1 The Open Space and Trails Committee met in teleconference session on Thursday, June 4, 2020
2 to discuss and if appropriate, take action on the agenda items listed below.

ATTACHMENT A

Open Space Committee Draft Parks Plan Review June 4, 2020

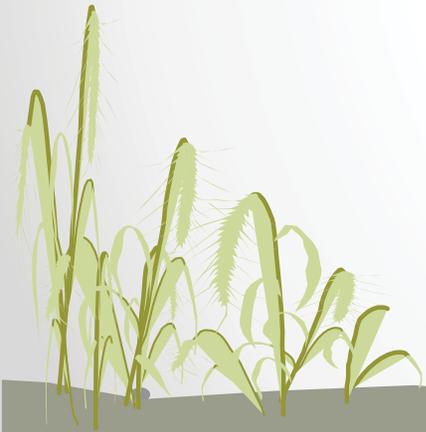
Staff's Comment- Page 25:

- Two pictures of the Gazebo.
 - To be corrected

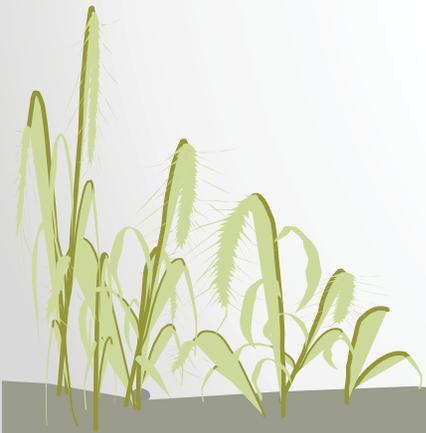
Carothers land reaches significantly farther west than is shown. It includes all the mature woodland and marsh reaching back to the small side creek that runs under Pine Gully Road (items 4, 5 and 6 on aerial, next page). The boundary in the draft plan should be extended westward.

Carothers land does not include residential development on Pine Gully Road. The park goes around the residence to the north and west. The boundary in the plan should be adjusted accordingly (see black boundary line on the aerial below).
